RE: Response to Comments, The Kingstonian, 9-21 N. Front Street, City of Kingston, Ulster County, New York; CM Project No. 118-025

Creighton Manning Engineering, LLP (CM) is in receipt of the October 7, 2019 comments from HVEA Engineers regarding the Kingstonian project in the City of Kingston. Below is a summary of the comments and our responses.

Photograph #1 – Sight Distance Looking Left

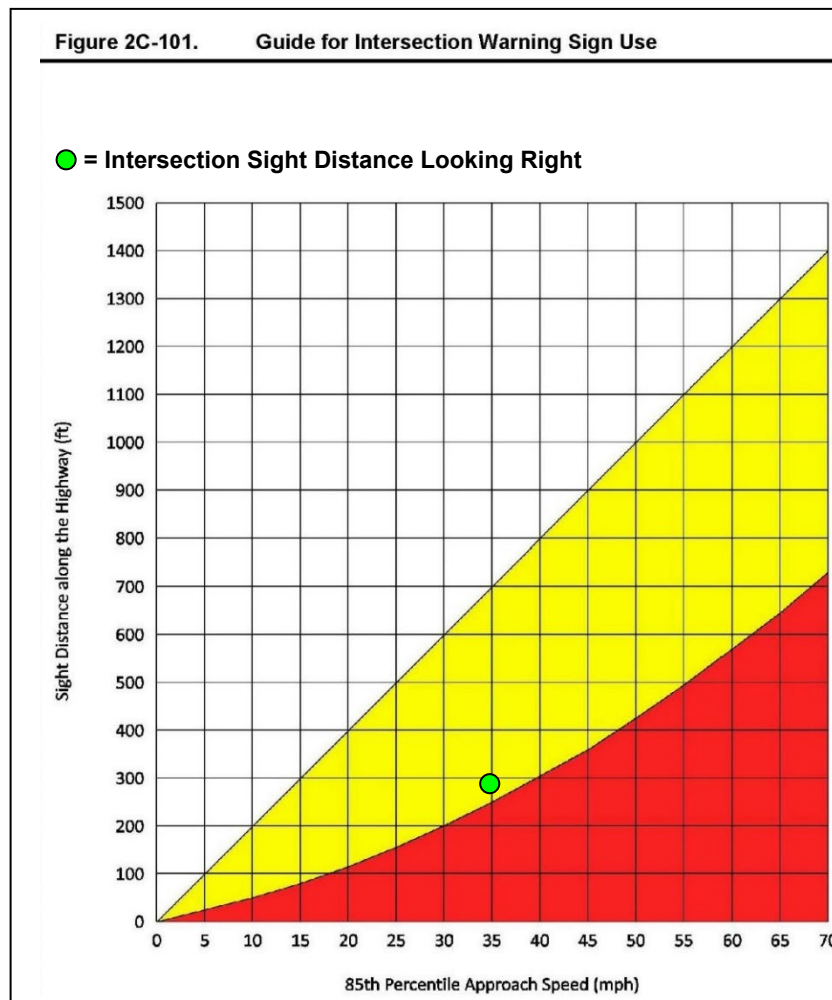
Comment #8: We suggest that, “The applicant be required to undertake an assessment of sight lines at the southern garage ramp on Schwenk Drive [and] demonstrate conformance with current standards.”

Response: A sight distance assessment was conducted at the proposed southern access on Schwenk Drive. The available *intersection* sight distance was measured from the perspective of a driver looking in both directions along Schwenk Drive to determine if adequate sight lines are available. The intersection sight distance looking straight ahead for vehicles traveling westbound on Schwenk Drive (i.e., those turning left into the proposed garage ramp) was also measured. The available intersection sight distance on a minor approach should provide drivers a sufficient view of the intersecting roadway to allow vehicles to enter or exit the intersection without excessively slowing vehicles traveling at or near the operating speed on the intersecting mainline.

The available stopping sight distance for vehicles traveling eastbound and westbound on Schwenk Drive and the distance looking straight for drivers turning left into the site exceeds AASHTO guidelines for a 35-mph operating speed. In addition, the available intersection sight distance looking left to make a right turn exiting the site also exceeds AASHTO guidelines for the 35-mph operating speed.

Drivers turning left out of the driveway also need to look right along Schwenk Drive. The available sight distance looking right is less than desirable at 35 mph. Figure 2C-101 found in the New York State Supplement (NYS Supplement) to the National Manual for Uniform Traffic Control Devices (NMUTCD) provides guidance for the installation of “Intersection Warning” signs as mitigation for sight distance. A review of Figure 2C-101 (see figure below) indicates that the available sight distance looking to the right at the Site Driveway is less than desirable, but not critically limited for a 35-mph operating speed and therefore an “Intersection Warning” sign is not recommended. It is recommended that any proposed vegetation and/or signage related to the site be placed a minimum of 15 feet back from the edge of the travel lane to maximize sight lines along the site frontage and provide clear lines of sight for vehicles exiting the site.
